Access Compliance Report

Public Rights-of-Way

(Curb Ramps)

Intersection ID: 6159	Main Street: ORR_ST	Cross Street: GRAYPARK_DR	Location: SW
ADA ID: F3D34748BAFE	Ramp Type: PerpDiag	Initial Pass/Fail: Fail	Overall Compliance: No
Severity Score: 10			
Codes/Mitigation Info/Possible Solution		Field Measurements/Component Compliance

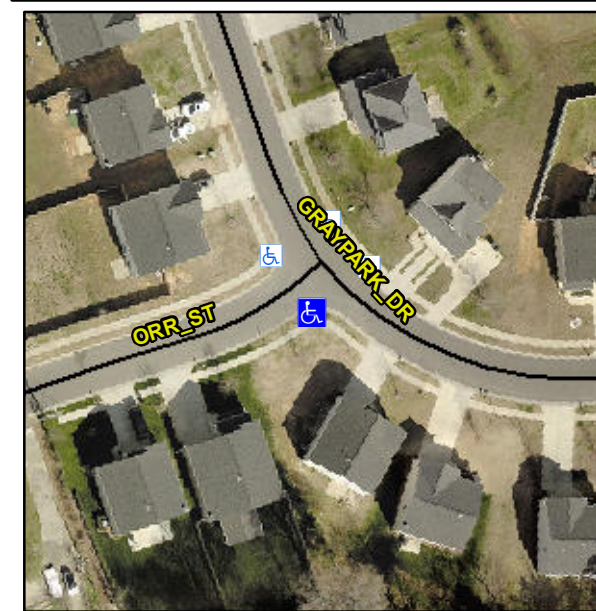
Not Found, R304.5.1, R304.5.3

Compliance	Description	Data	Compliance	Description	Data
N/A	Ramp Length (in)	49.0	Yes	Ramp Slope (%)	6.8
No	Ramp Width (in)	47.5	No	Ramp XSlope (%)	2.6
N/A	Flare Type LT	N/A	N/A	Flare Type RT	N/A
N/A	Flare Slope LT (%)	N/A	N/A	Flare Slope RT (%)	N/A
N/A	Flare Traversable LT?	N/A	N/A	Flare Traversable RT?	N/A
N/A	Landing Length (in)	N/A	N/A	DWS Provided?	N/A
N/A	Landing Width (in)	N/A	N/A	DWS Contrast?	N/A
N/A	Landing Slope (%)	N/A	N/A	DWS Length (in)	N/A
N/A	Landing X Slope (%)	N/A	N/A	DWS Full Width?	N/A
N/A	Landing Curb? (Y/N)	N/A	N/A	DWS Offset (in)	N/A
N/A	Shared Landing?	N/A			
N/A	Gutter Ponding?	N/A	N/A	Gutter Slope (%)	N/A
N/A	Gutter Lip Ht (in)	N/A	N/A	Gutter X Slope (%)	N/A
N/A	Painted X Walk1?	No	N/A	Painted X Walk2?	No
	X Walk 1 Direction	To NE		X Walk 2 Direction	To NW
N/A	X Walk 1 Width (in)	N/A	N/A	X Walk 2 Width (in)	N/A
	X Walk 1 Slope (%)	3.4		X Walk 2 Slope (%)	2.1
	X Walk 1 X Slope (%)	2.0		X Walk 2 X Slope (%)	1.7

Remove & Replace Curb Ramp With Two New Directional Ramps or Equivalent.
